Review of Groundwater Issues Associated with the Proposed Bylong Project

Independent Planning Commission NSW

Dr Lloyd Townley

5 March 2019

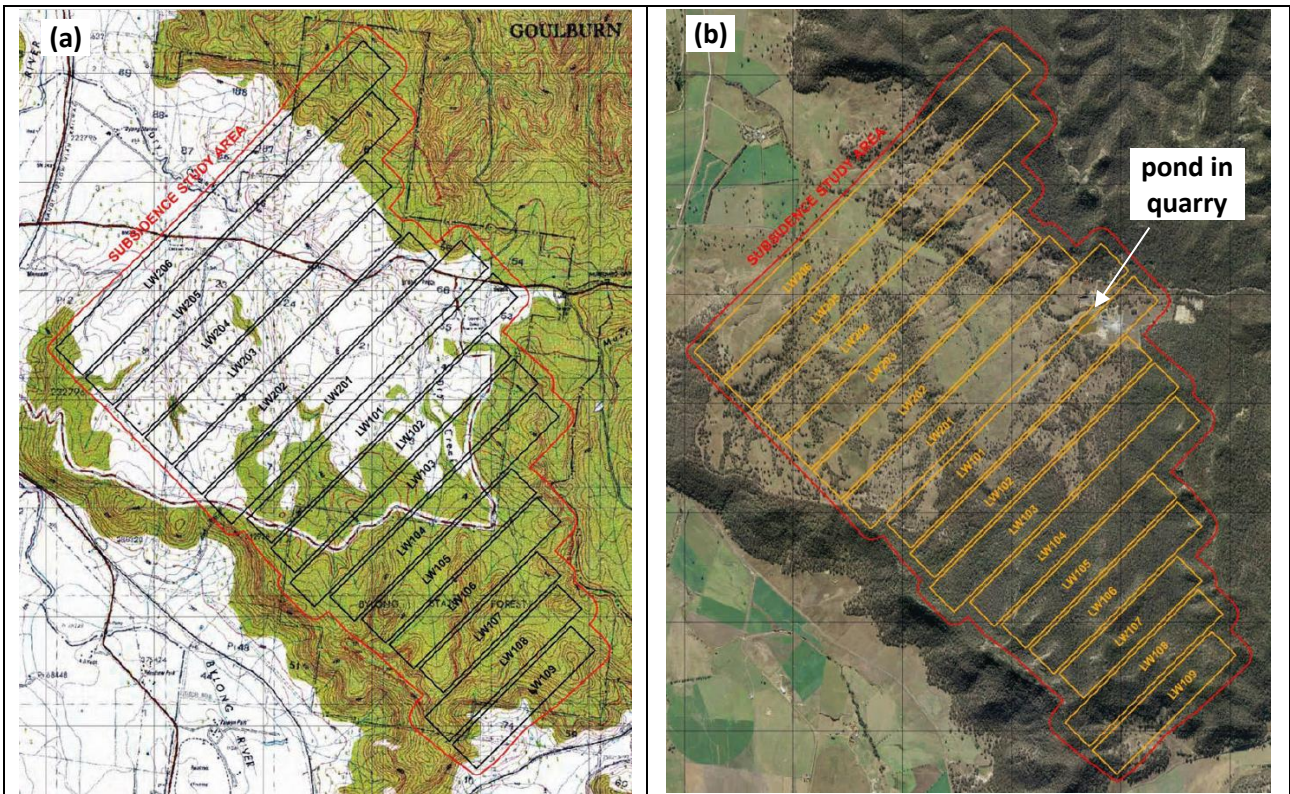
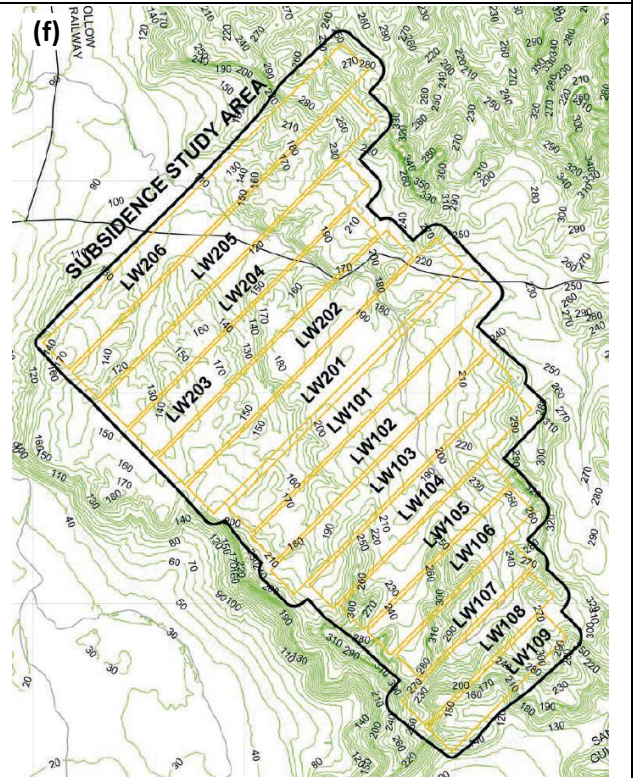
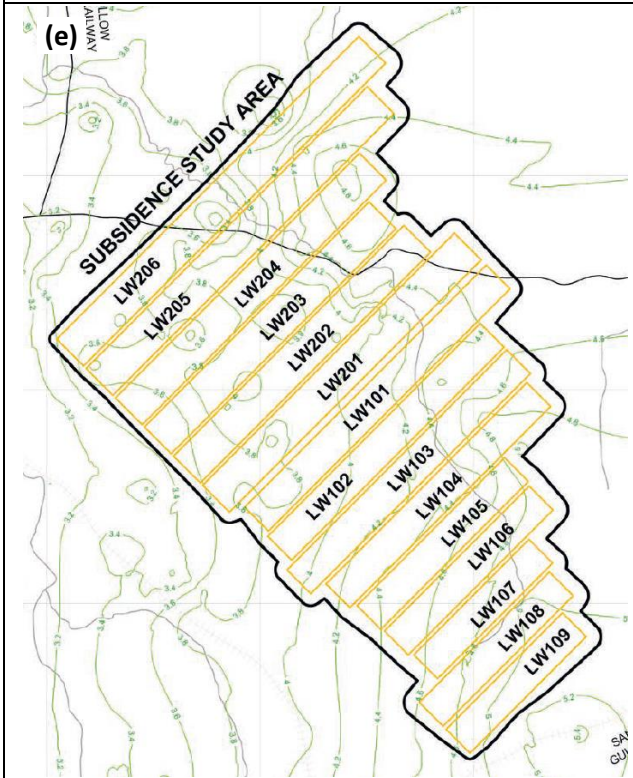
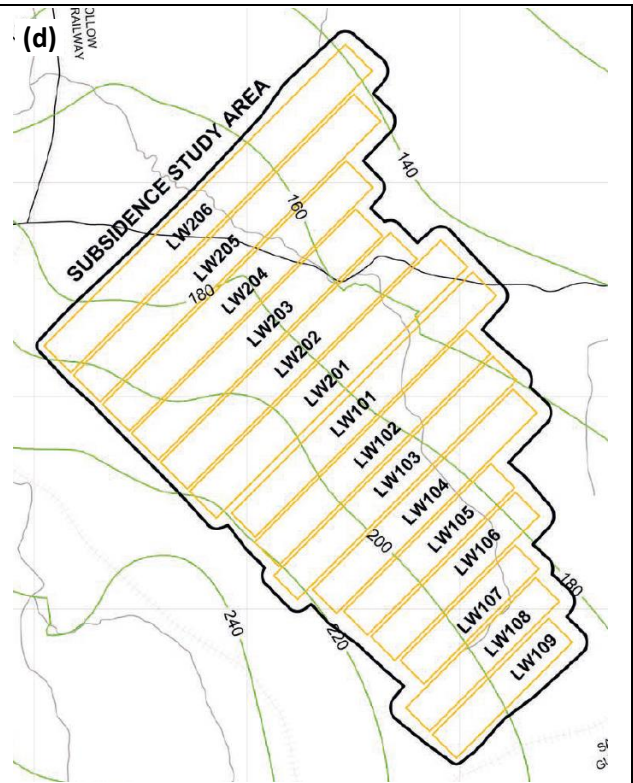
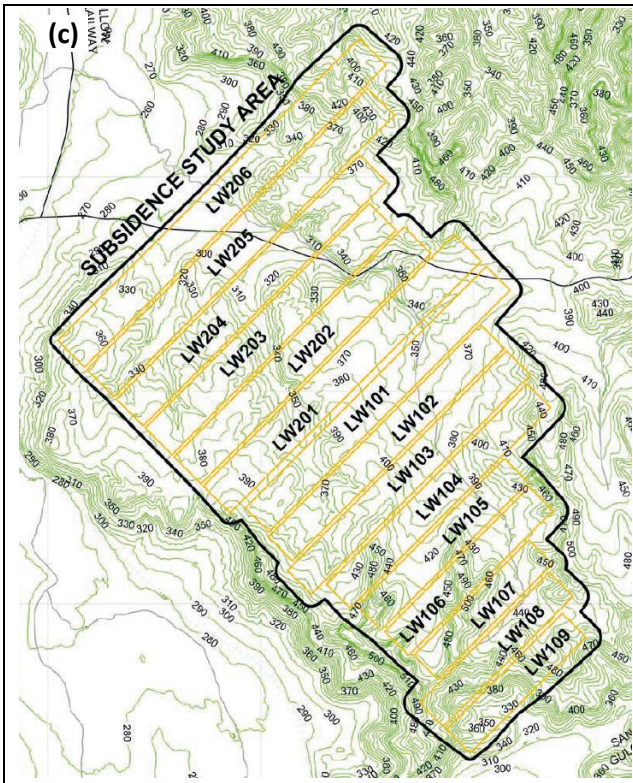
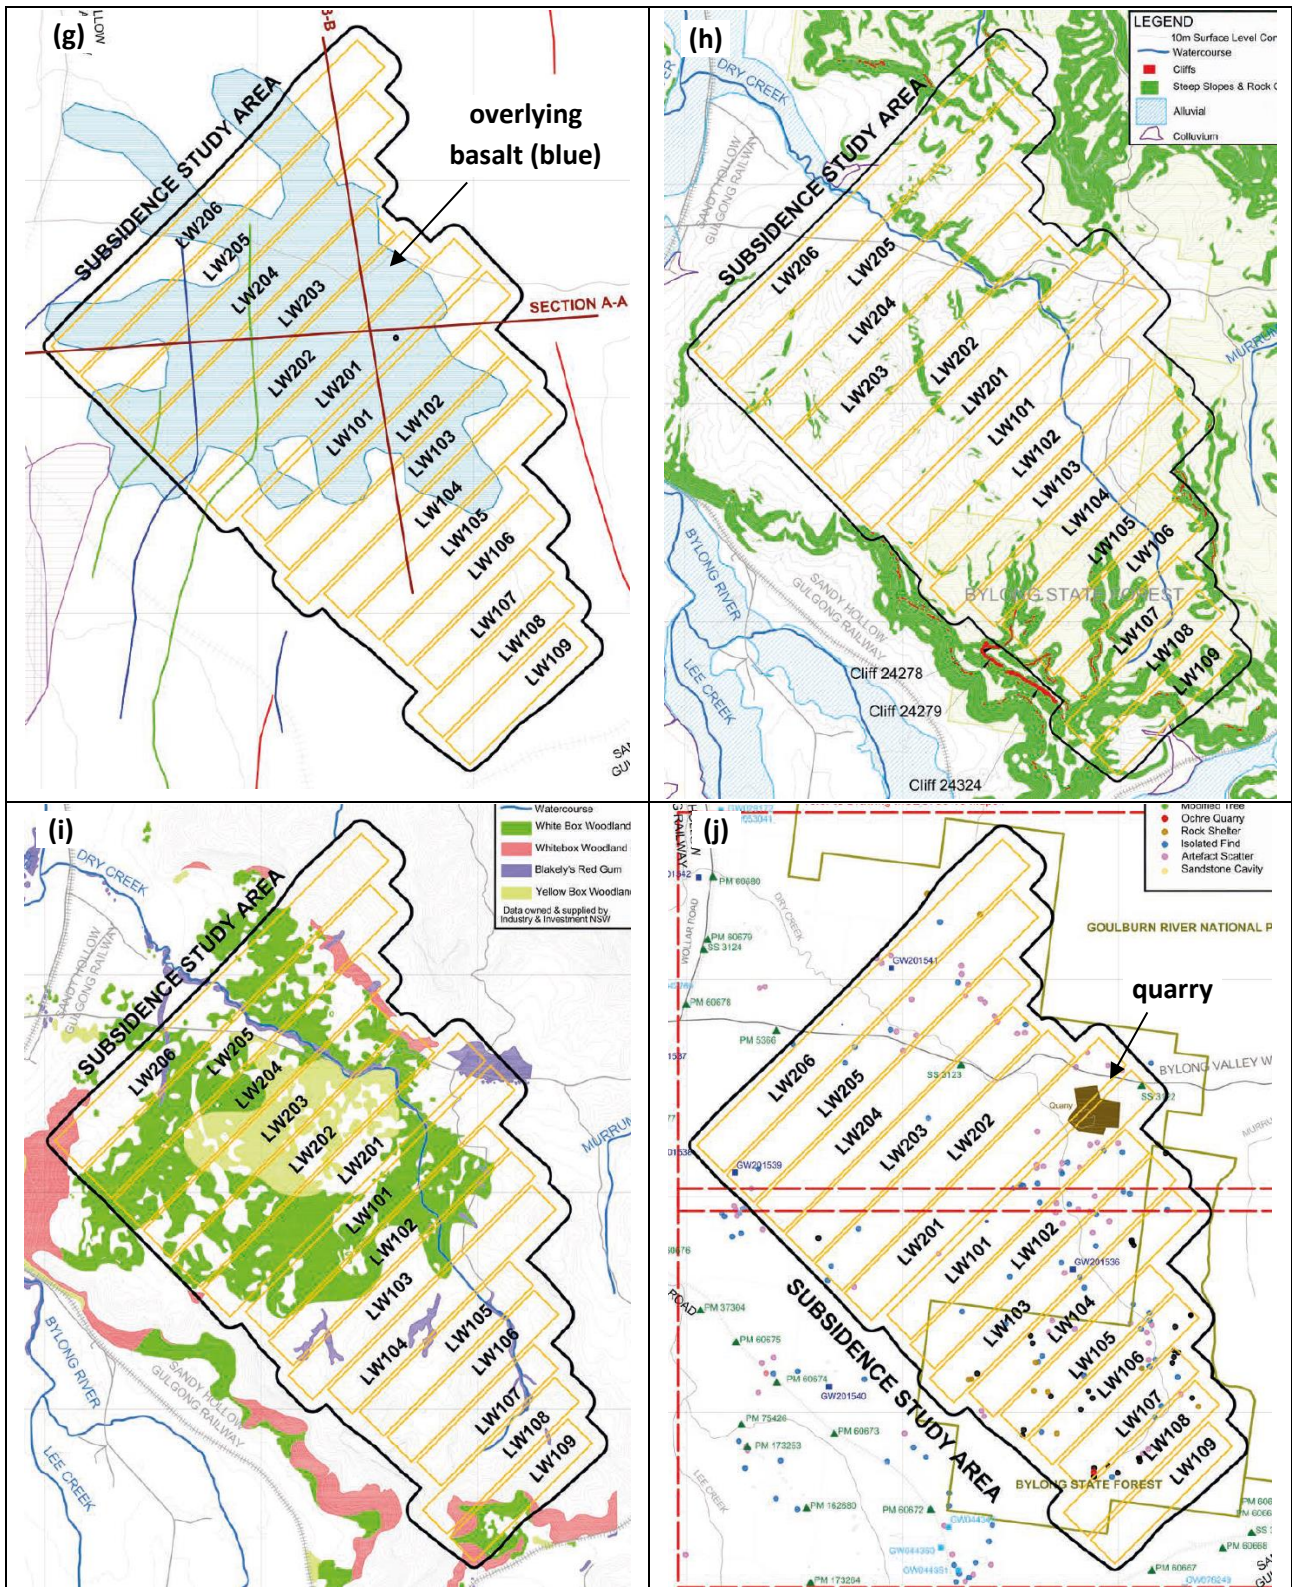
Figure 4(d) above shows the elevation of the base of the Coggan Seam. If longwall mining commenced at the northeast end of LW206, at the deepest part of the underground mine, then for practical and safety reasons, storage in the goaf of this deepest part of the mine may be feasible. The Applicant’s mining engineers must be aware of the possible need to store excess water in the underground mine and of practical issues. Mine plans and schedules can be adjusted when there is a reason to do so, even if there is an associated cost. If the mine is approved, the Applicant will learn a lot during mining of the first panel LW101. The mine will be found either to be relatively dry or relatively wet, and new predictions of water balance throughout the life of mine will be possible. By starting at LW101, as planned, the Applicant would have enough time to adjust the mine schedule in response to what is learned.

Figure 5. History of groundwater investigations and numerical modelling, based on Figure 2.1 in AGE (2017)

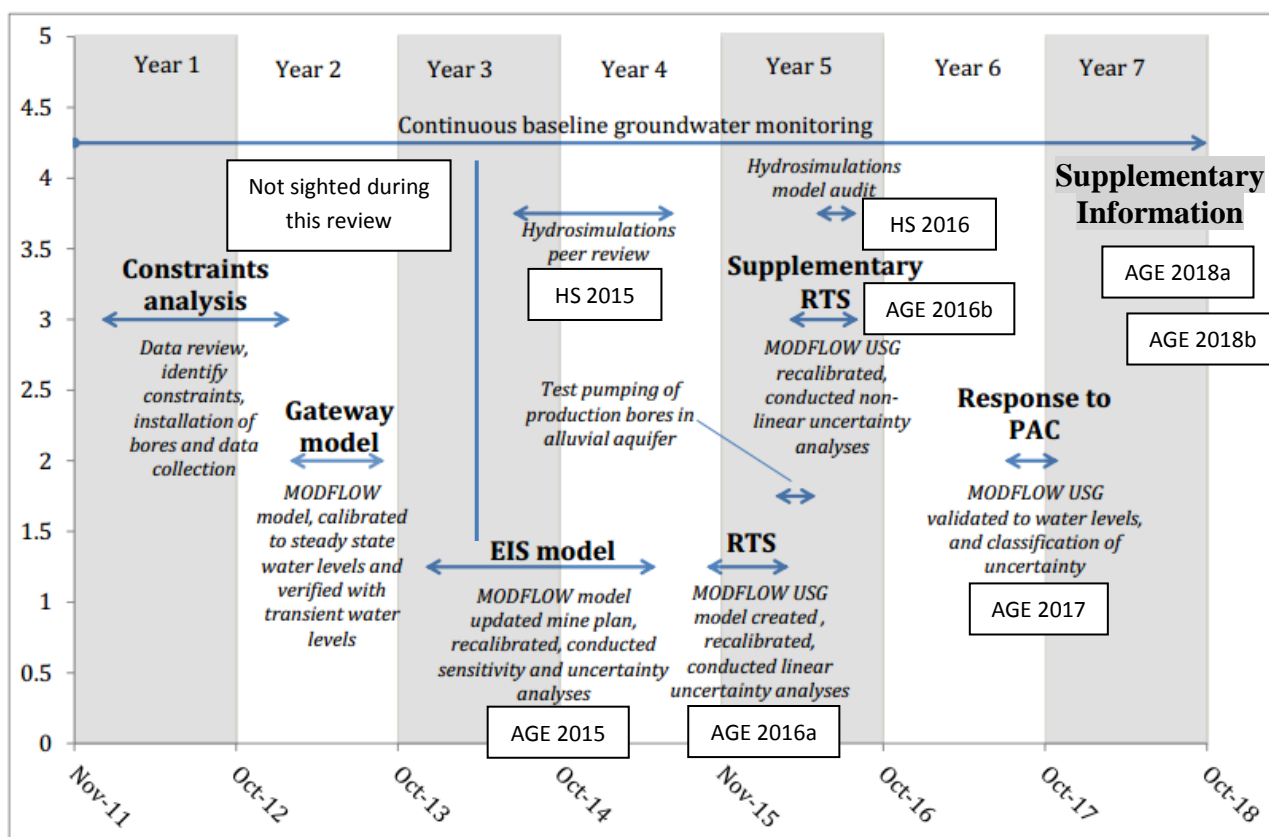
- In response to a suggestion by the PAC, the Department used a Figure provided by AGE (2017), reproduced in Figure 5 above, with additional annotation, to explain the history of hydrogeological investigations and modelling during the project. This Figure is very useful, however as suggested in Section 4.3.2 above, it would have been useful to expand the description of the conceptual hydrogeological model, to explain the processes that are expected to occur. It is no doubt still difficult

mining operations, but is difficult to audit, largely because the predictions made in the EIS and all subsequent reports (see Figure 5 above) are not presented in a form that is easily auditable. The same comment about auditability can be made in relation to the third row in Table 8, because there are no individual quantitative predictions for Bylong River, Lee Creek, Dry Creek and Growee River, and it is almost impossible to audit against predicted statistics.

Figure 6: Schematic section showing conceptual hydrogeology, based on Figures 7-21 in AGE (2015)

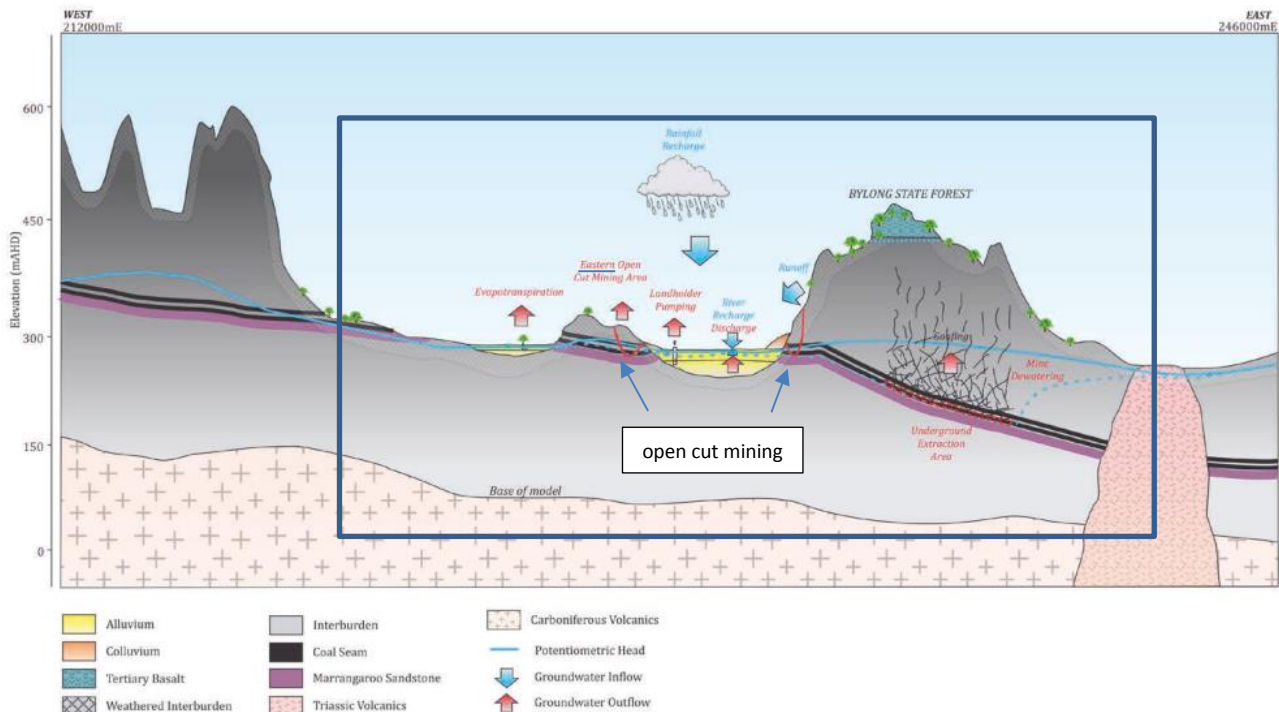
Figure 6 is not a particularly good schematic, as it leaves many questions open. The Figure shows the water table before and after mining, and processes during mining. If the two areas of alluvium are intended to represent Lee Creek and Bylong River, they should have been labelled, and it would then make sense to show the Western Open Cut Mining Area to the west of Lee Creek and to remove what appears to be open cut mining on the Bylong State Forest side of Bylong River. It is not clear that this Figure communicates to stakeholders that the authors understand the full range of “groundwater issues” listed in Section 4.2 above, before, during and after mining, or other issues not identified by the reviewer. A sequence of Figures at different times could explain a lot more.

Figure 7: Regional water table, Figure 7-8 in AGE (2015)

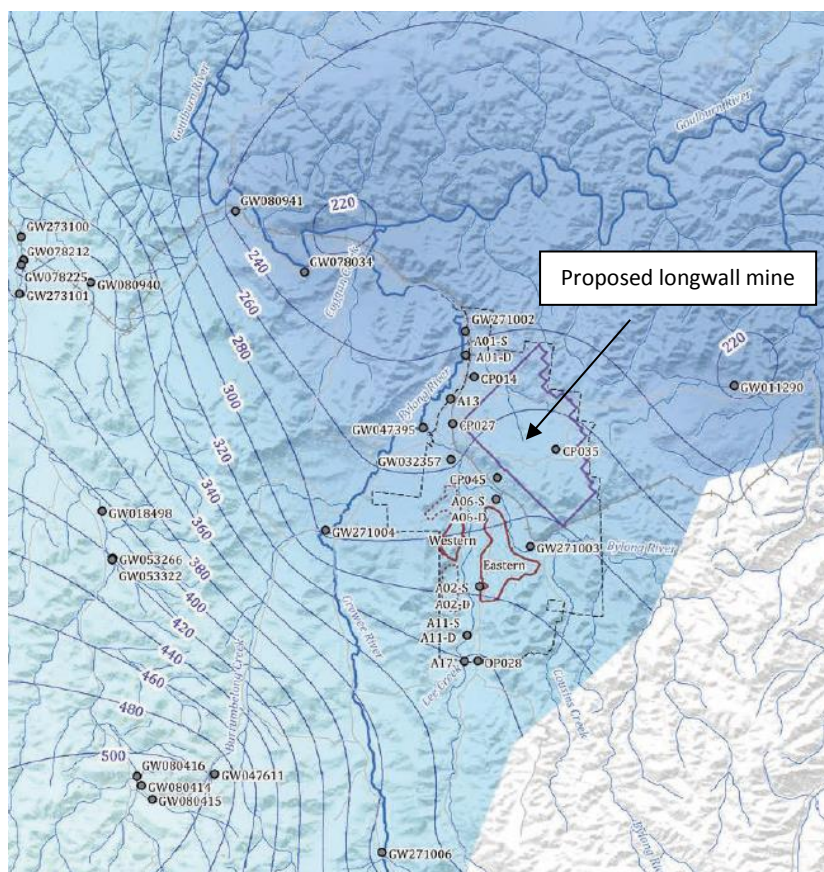
AGE (2017) do not update their interpretation of the regional water table. Figure 4-1 in this report shows depth to water table in the Coggan Seam. The smoothness of the colours in the top right of Figure 4-1 suggests that the water table is still believed to be as shown in Figure 7 below.

Knowledge of the shape of the regional water table above the proposed longwall mine is important because it affects the potential for groundwater inflows to the underground mine, especially by vertical drainage if goafing causes fracturing to and above the elevation of the water table.

Figure 10: Predicted contours of pressure head beneath the water table (Figure 10.18 from AGE 2015)

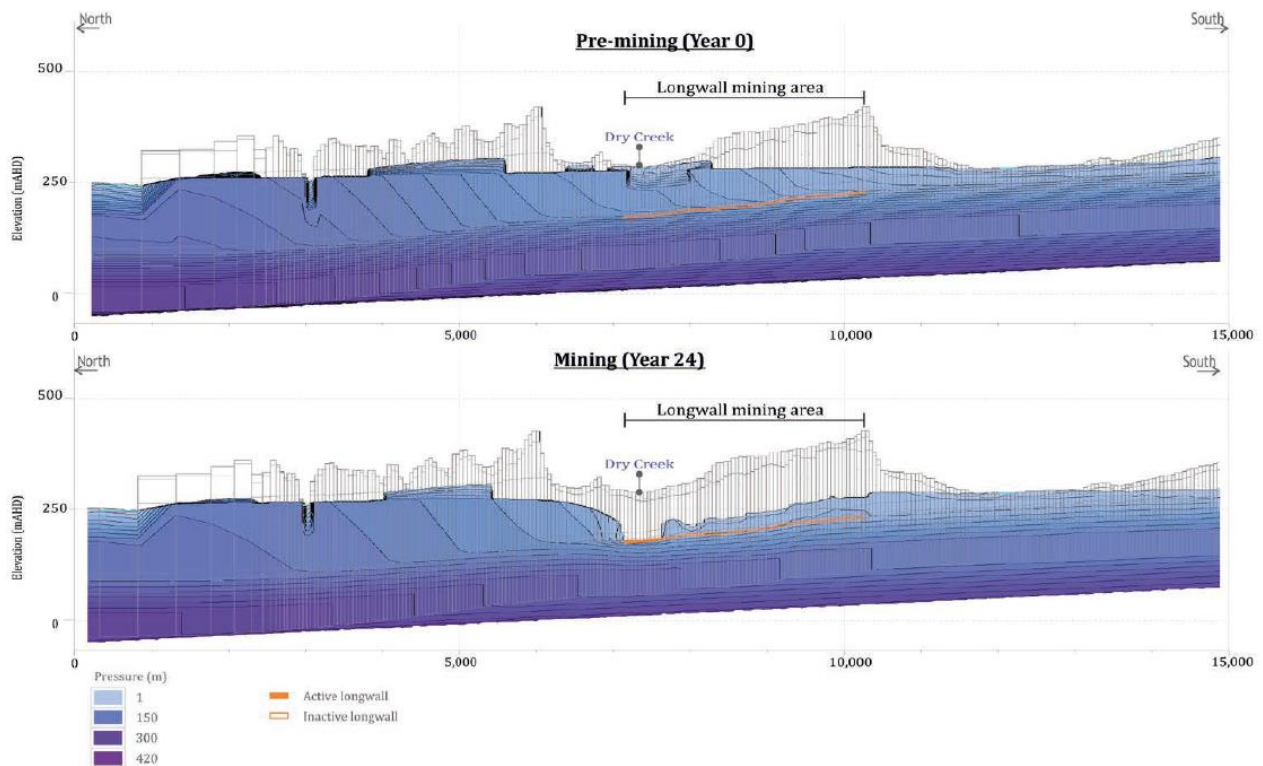
While AGE has not explained their modelling in the context of recent research, one submission on the EIS referred to Tammetta (2015), and Section 5.9.18 of HB (2016a) therefore discusses the Applicant's modelling in the context of this work. The response points to Figure 10.15 and 10.18 in AGE (2015), where drawdown over the mine panels is "complete". In fact, Figure 10.15 shows depressurisation in the Coggan Seam, which is necessary for mining, but the remaining question is whether a water table remains above the mine, or not. Figure 10.18 suggests that the water table would indeed be drawn down, because MODFLOW-SURFACT was being run in a mode that did not support an unsaturated zone, or a perched saturated zone above an unsaturated zone.
